# 2<sup>ND</sup> & PINE

DOWNTOWN DRB RECOMMENDATION MEETING

DPD #3014773 | JANUARY 7, 2014

# BOARD GUIDANCE AT EDG – SUMMARY

# CODE COMPLIANT MASSING VS. PREFERRED MASSING

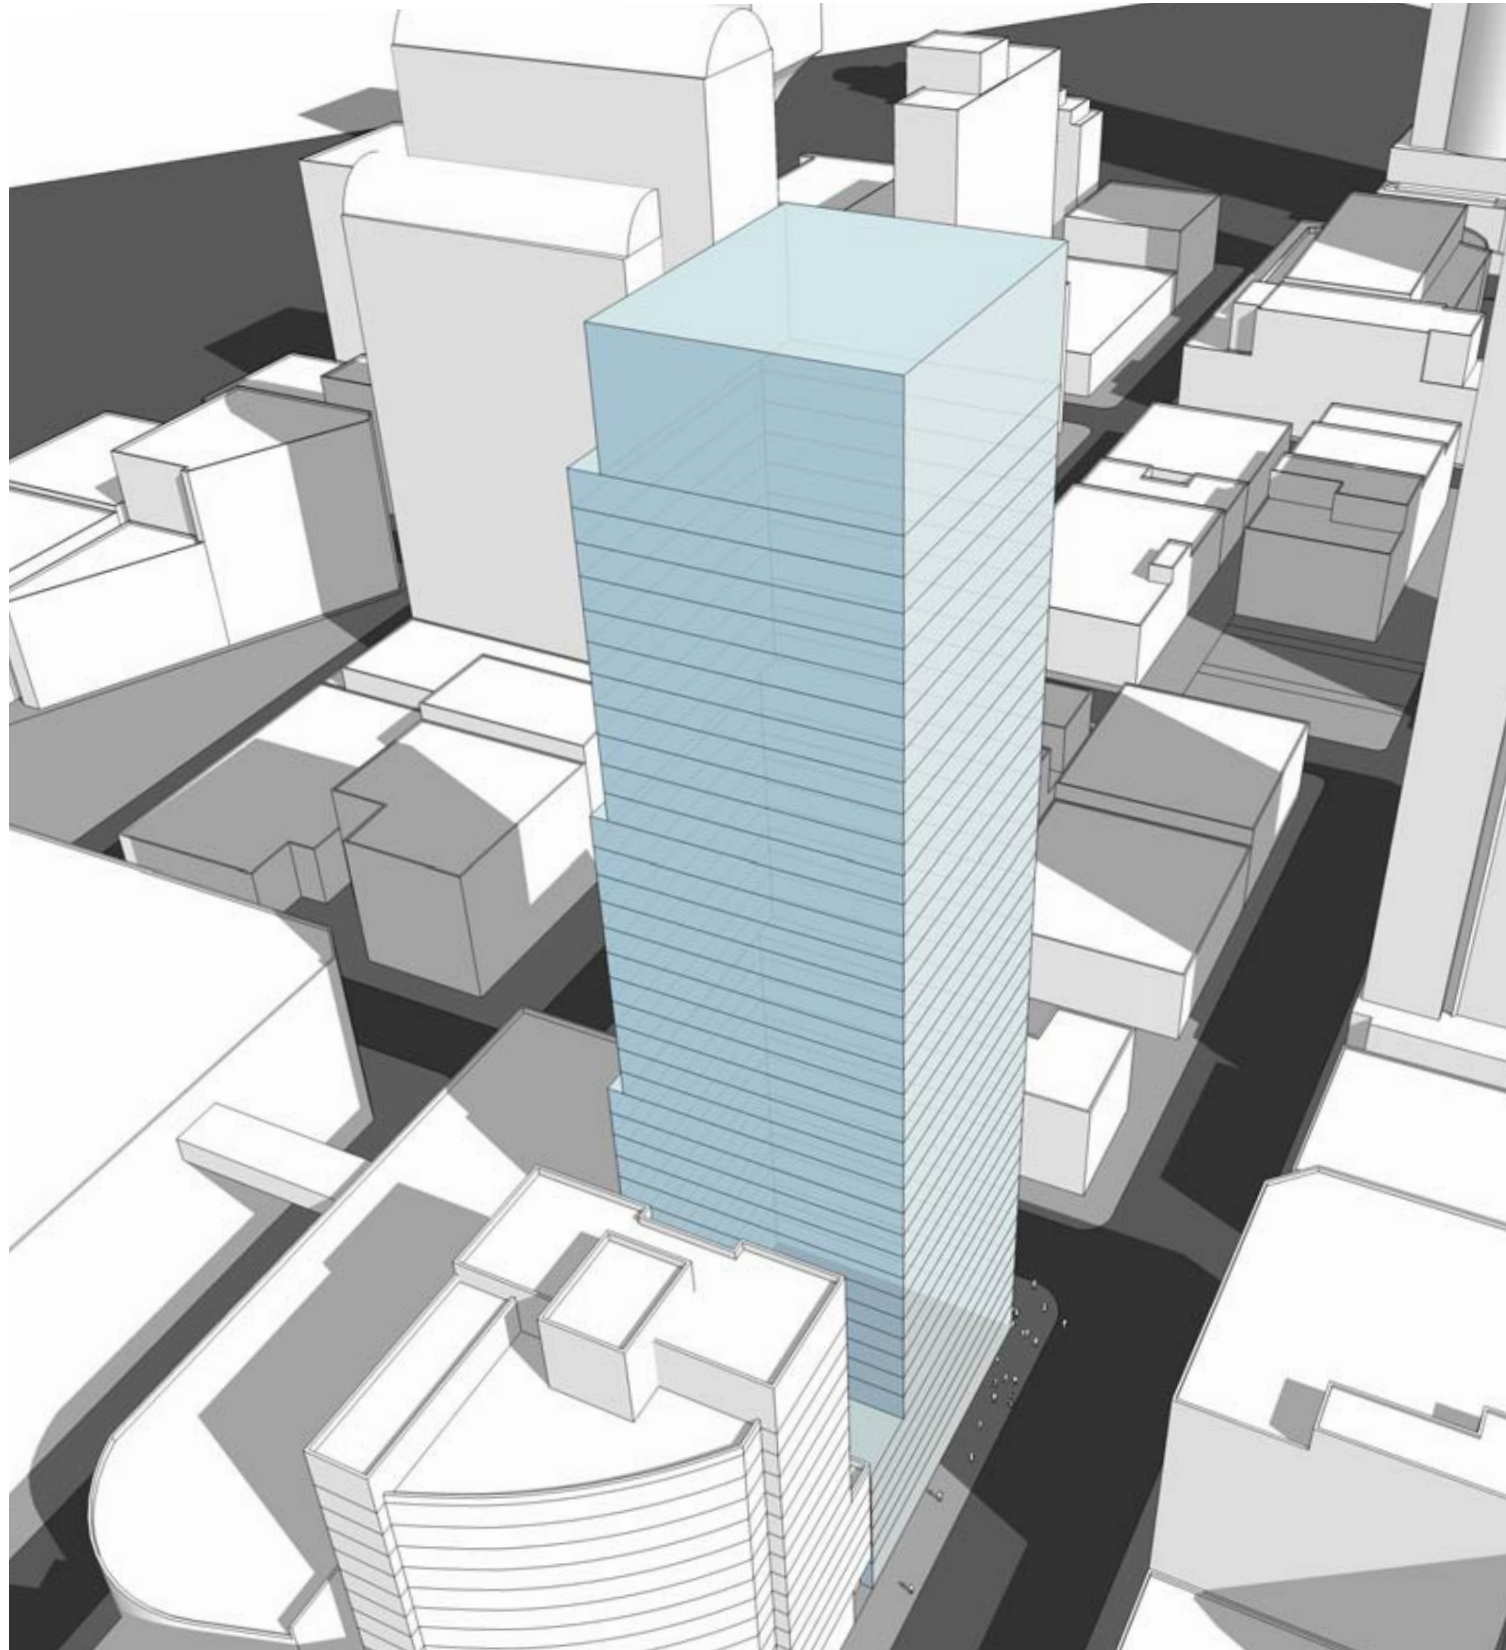
B-3: Develop a viable, comparable code-compliant tower option (specifically the 105 ft maximum north-south façade length) for consideration at the Recommendation meeting.

**Response:** The code compliant response has been included in several illustrations and provides stark contrast to our proposal.

# REQUESTED DEPARTURE #1

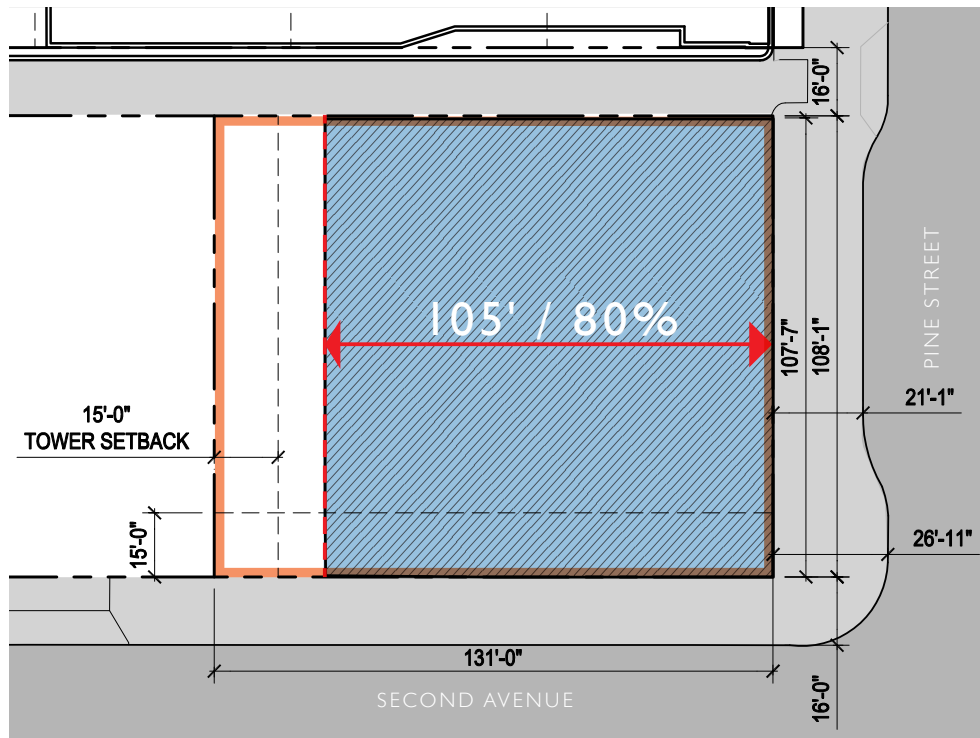
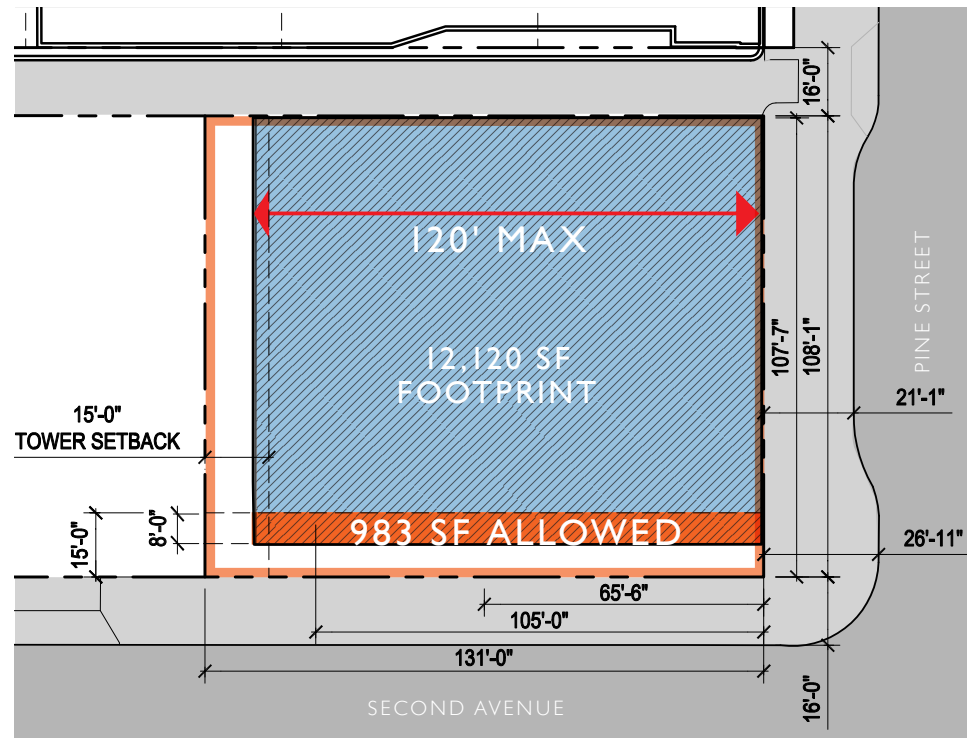
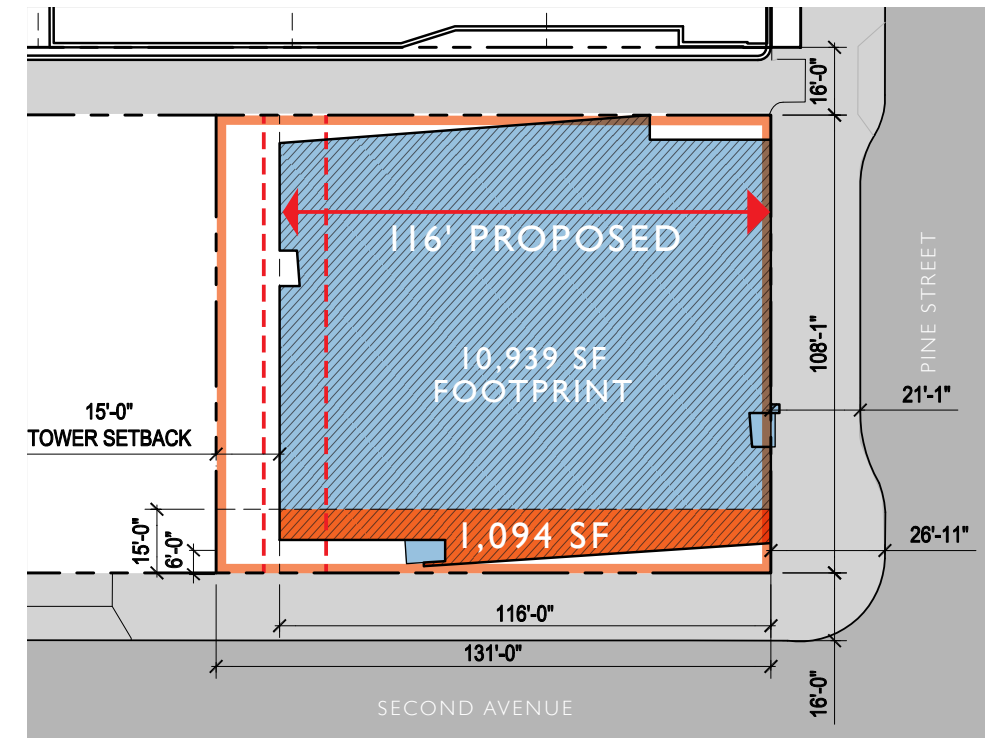
DEVELOPMENT STANDARDS	REQUIREMENT	PROPOSED	DIFFERENCE	CONSIDERATIONS
<b>SMC 23.49.058.D2</b> MAXIMUM TOWER WIDTH	In DMC zones, the maximum facade width for portions of a building above eighty-five (85) feet along the general north/south axis of a site (parallel to the Avenues) shall be one hundred twenty (120) feet or eighty (80) percent of the width of the lot measured on the Avenue, whichever ever is less. On a lot where the limiting factor is the eighty (80) percent width limit, the facade width is one hundred twenty (120) feet, when at all elevations above a height of eighty-five (85) feet, no more than fifty (50) percent of the area of the lot located within fifteen (15) feet of the street lot line(s) is occupied by the structure	The proposed tower is approximately 116'-0" wide, which equates to 88.5% of the 131'-0" lot width. 1,094 SF of building structure occupies the 15'-0" zone parallel to Second Avenue.	+8.5% lot width = +11'-0" 1094 sf within 15 ft zone = 111 sf (+11%) over the 983 sf allowed	The modulated facade along 2nd Avenue is approximately 116' wide. The massing tapers at the southwest corner and intersection of Second Avenue and Pine Street, slenderizing the southernly facade. The modulation along Second Avenue reflects the grid shift along Second Avenue and creates an interlocking niche with decks that climb the height of the tower to create texture and slender massing within the facade.

# REQUESTED DEPARTURE #2

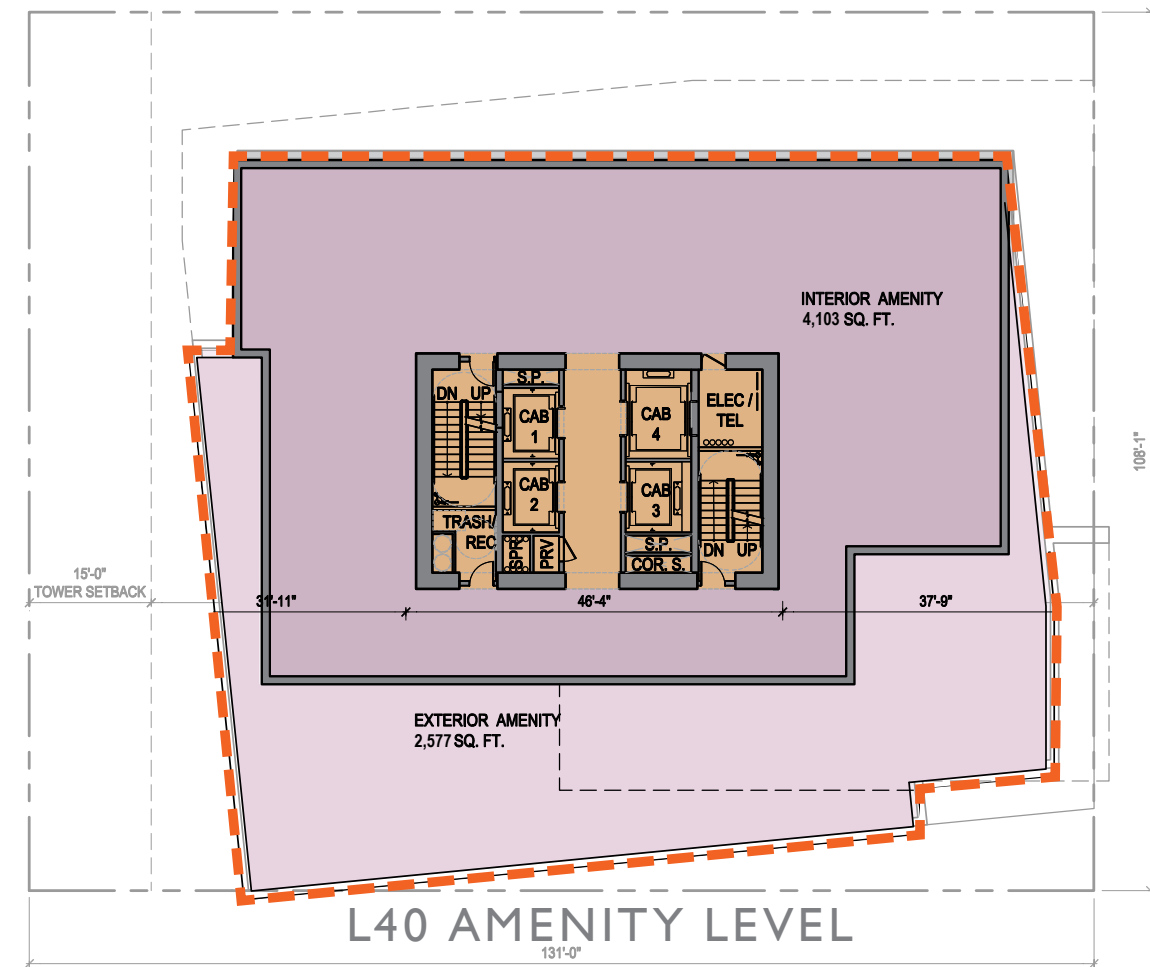
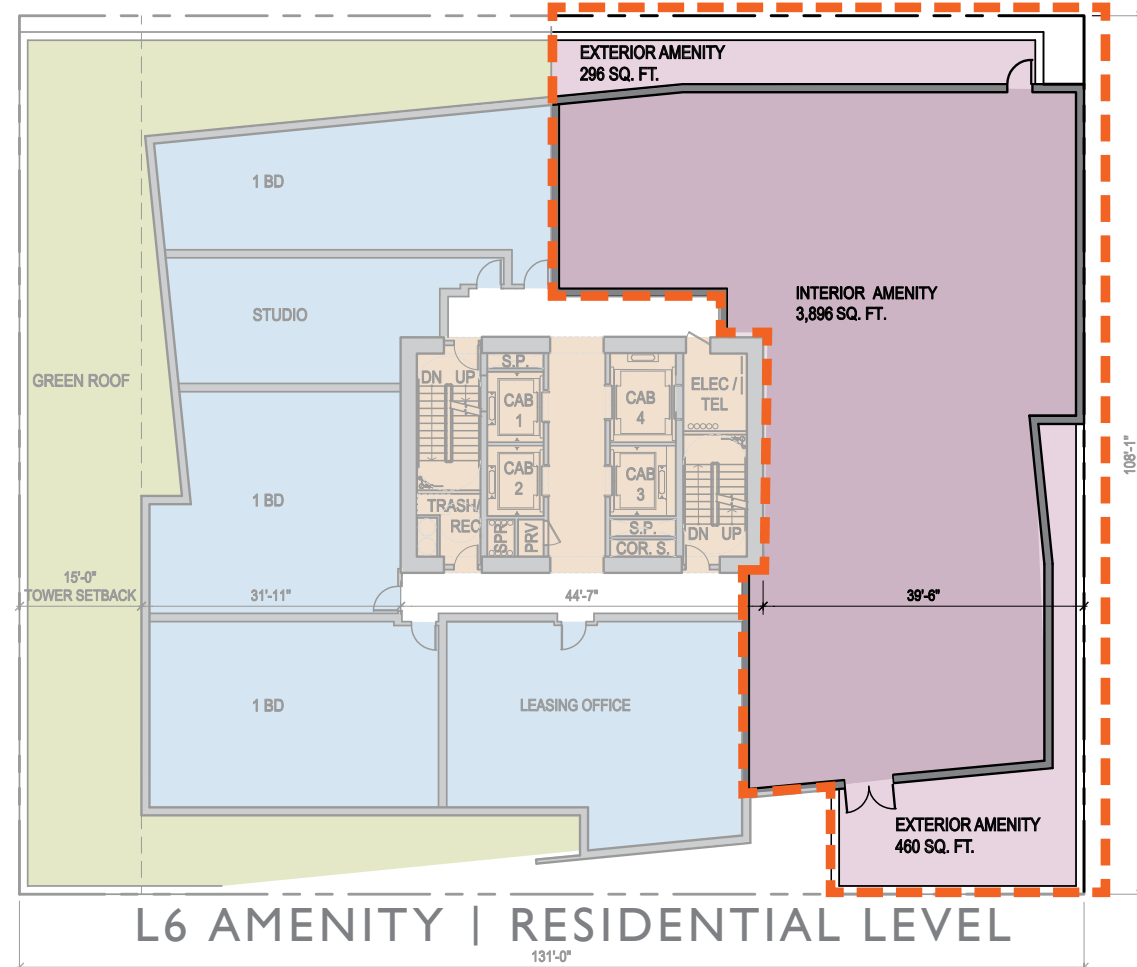
We propose a total of 11,310 SF of Common Recreation space including areas less than 15' in width. The total Common Recreation meeting SMC 23.49.010.B2 equals 9,705 SF: 7,366 SF of interior common recreation meets the 15' minimum horizontal dimension, while 2,339 SF of exterior common recreation meets the 15' minimum horizontal dimension.

Approximately 10,667 SF Total Required common recreation – 9,705 SF provided = (-962) SF  
**50% of enclosed common recreation 5,333 SF MAX** – 7,366 SF provided = +2,033 SF

Ground level uses will provide additional amenity to residence to satisfy net difference of current common recreation area. The common recreation space that includes a horizontal dimension of less than 15 feet = 11,310 SF, which is +643 SF the requirement.

# REQUESTED DEPARTURE #3

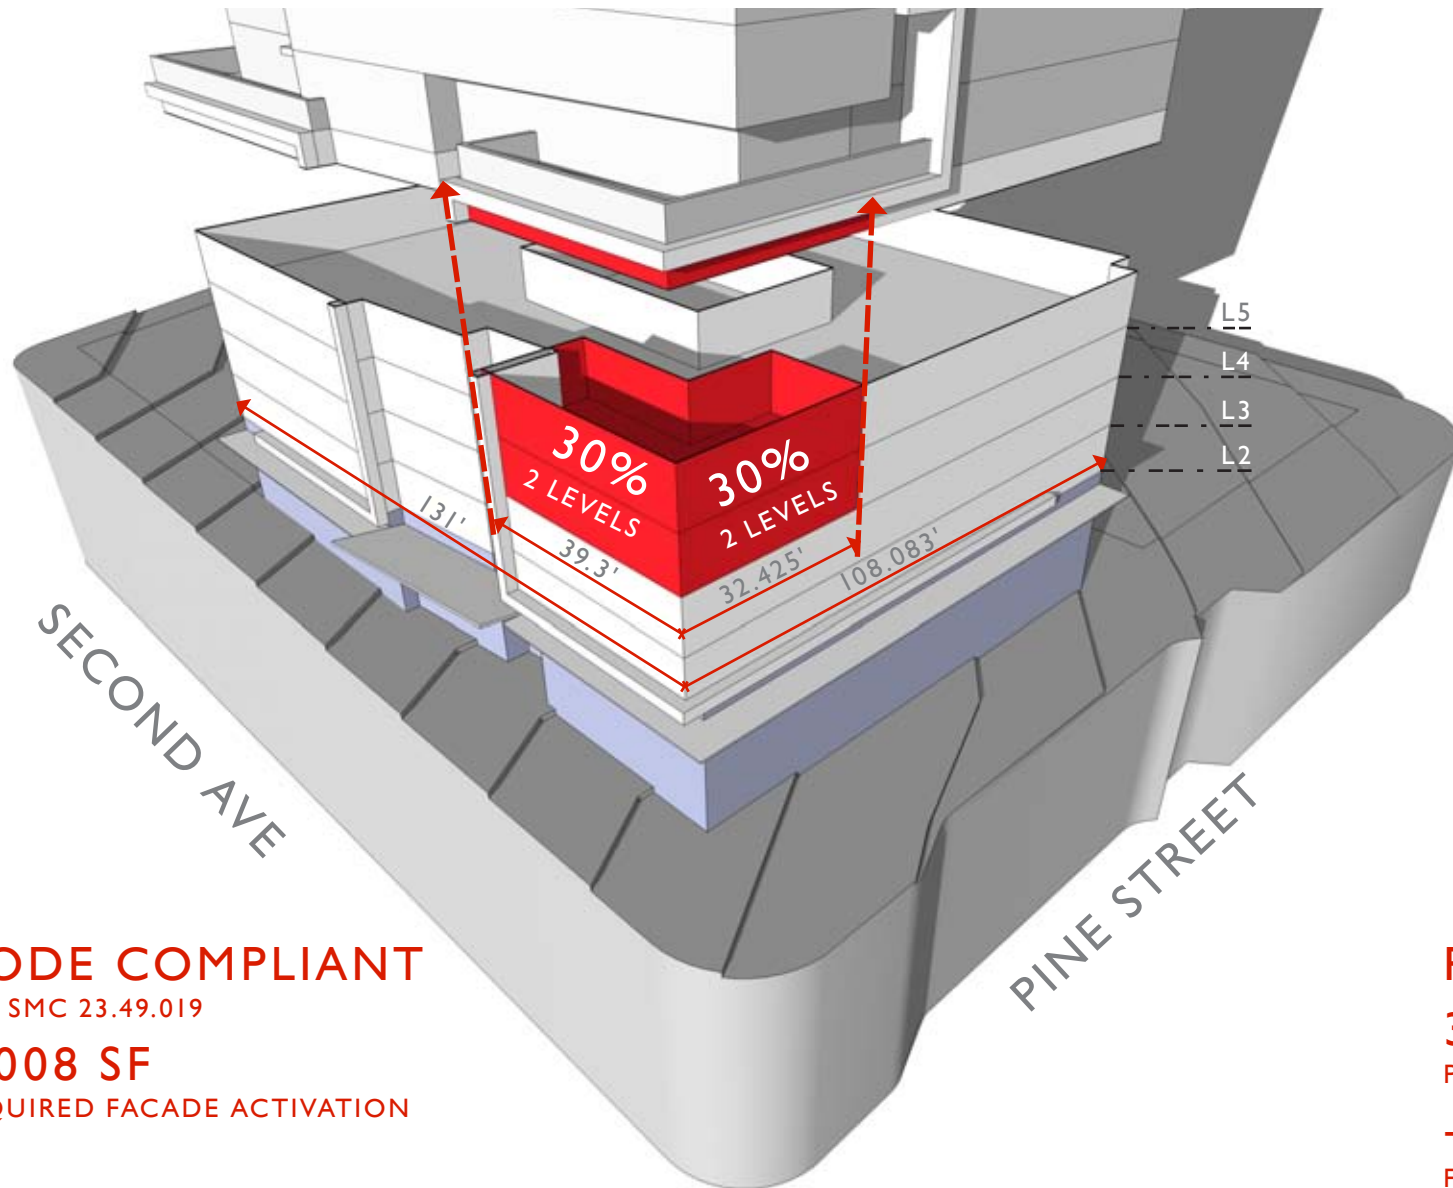
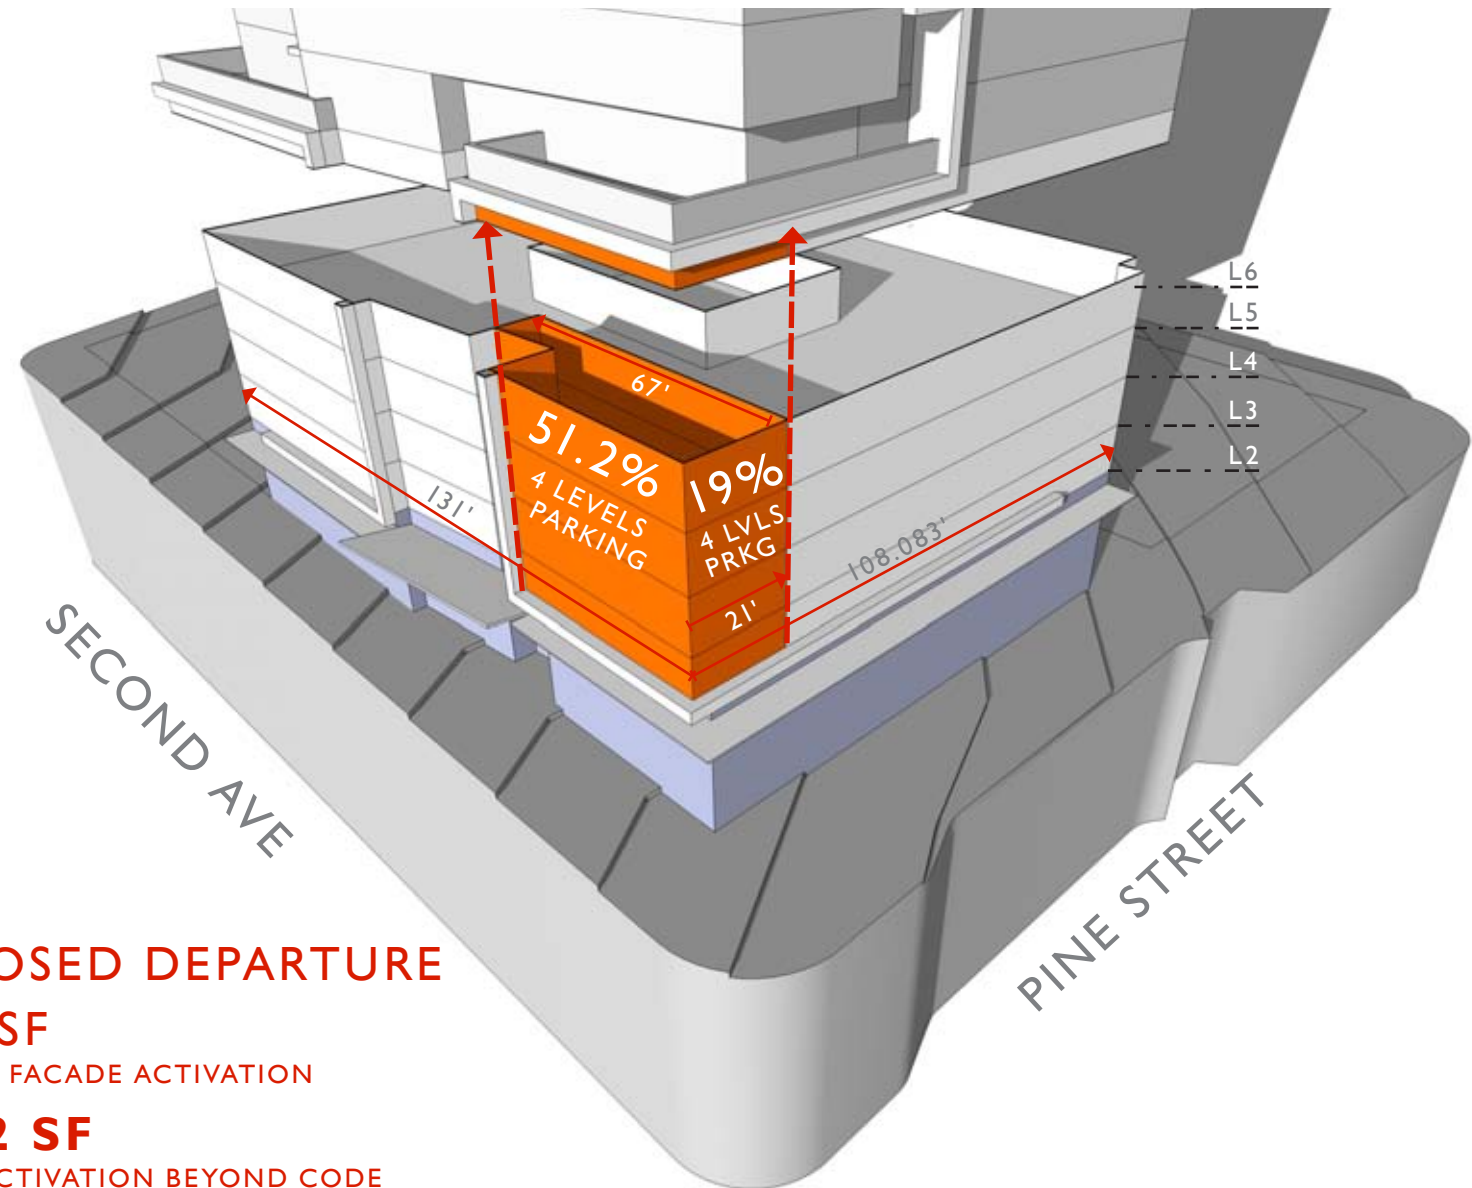
A Departure is requested to reduce the alternative use minimum of 30% street frontage above level three along Pine Street to 16% street frontage activation over four floors with micro residential units on levels 2 through 5.

PINE STREET:  
 $108' \times 30\% = 32.4'$  over two floors required along Pine Street, for a total of 64.8' street frontage. Reduce to  $108' \times 19\% = 21'$  over five floors, for a total of 105' street frontage.

SECOND AVENUE:  
 $131' \times 30\% = 39.3'$  over two floors required along Second Avenue, for a total of 78.6' street frontage. Expand to  $131' \times 51.2\% = 67'$  over five floors, for a total of 335' street frontage.

The concentration of residential units on the corner of Second and Pine activates the primary intersection of the project, bringing life to the street, while meeting the intent of the code in a concentrated effort. The street frontage activation along Second Avenue exceeds the required  $131' \times 30\% = 39.3'$  over two floors by 27.7' over two additional floors. The 2,008 sf required facade activation is therefore exceeded by +1,952 sf beyond code requirement given the 3,960 sf provided facade activation concentrated at the main intersection of Second Avenue and Pine Street.
